## 15. TRANSIENT AND ACCIDENT ANALYSES

### 15.1 Introduction

In the design control document (DCD), Tier 2, Revision 6, Chapter 15, "Safety Analyses," the applicant discussed the analysis of various anticipated operational occurrences (AOOs) and accidents. The system response analyses are based on the equilibrium core (EC) described in Chapter 4 of DCD and core loading documented in NEDC-33239-P, "Global Nuclear Fuel, GE14 for ESBWR Nuclear Design Report," Revision 4, March 2009. The staff reviewed the Economic Simplified Boiling-Water Reactor (ESBWR) transient and accident analyses in accordance with Chapter 15, "Accident Analysis," of NUREG-0800, "Standard Review Plan for the Review of Safety Analysis Reports for Nuclear Power Plants" (hereafter referred to as the SRP), Draft Revision 3, issued April 1996. The staff used the later version of SRP Section 15.0, "Introduction—Transient and Accident Analyses," Revision 3, issued March 2007, only for defining different event categories.

**Figure 15.1-2 Typical ESBWR Startup Path**

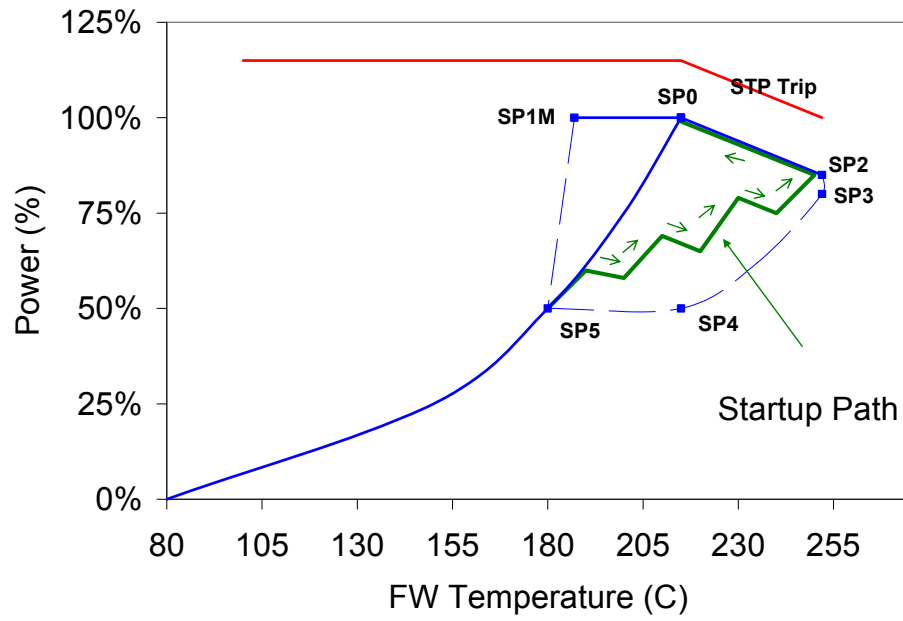
One of the primary advantages of the FWTOD is realized during reactor startup. Figure 15.1-2 shows a typical startup path for the ESBWR. Up to point SP5, the operator simply pulls control blades with feedwater heaters Nos. 1 through 6 fully open and feedwater heater No. 7 closed, because rod heatup is not a concern when the power is below 50 percent. As the power

Figure 15.1-3 ESBWR Operating Domain Showing Protection and Control Functions

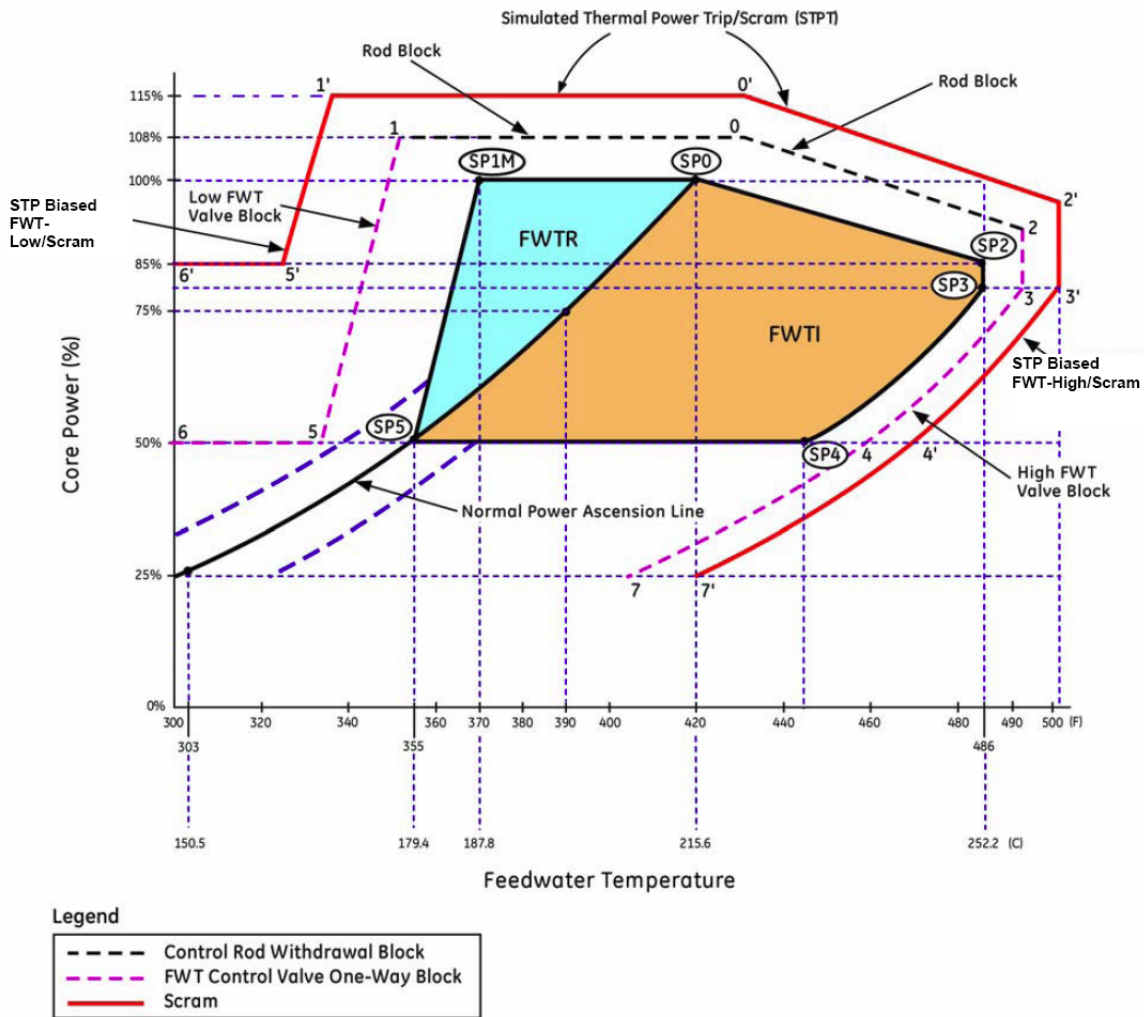
Figure 15.1-3 shows a detailed FWTOD map that defines not only the operating domain but also the protection system actuation lines, as well as the control system blocks on control rod and feedwater valve actuation. These blocks indicate the region where operation is restricted by means of the conventional control system. Unintended operation outside this region results in a control room alarm.

- In RAI 4.3-16, the staff requested the applicant to explain how the power-temperature operating domain will be defined. In response to RAI 4.3-16, GEH added a reference to NEDO-33338 in COLR Section 5.6.3 (b)(8) to indicate that the staff had approved the analytical method used for determining the cycle-specific operating thermal and stability limits.

- In RAI 4.3-25, the staff requested the applicant to explain whether it is possible to use the region between SP0 and SP1M to provide an end-of-cycle stretch. In response to the staff's RAI 4.3-25 (MFN 08-653 dated August 27, 2008), the applicant stated that if a future licensee or applicant intends to use the region between SP0 and SP1M for an end-of-cycle stretch, additional analyses similar to those required for end-of-cycle stretch for operating BWRs will be performed. If in the future, a licensee intends to implement low-temperature EOC stretch, additional analyses as stated above will need to be performed and reviewed. Since the applicant meets the regulatory requirements and based on the applicant's commitment to provide additional analyses for end-of-cycle stretch operation, RAIs 4.3-16 and 4.3-25 are resolved.
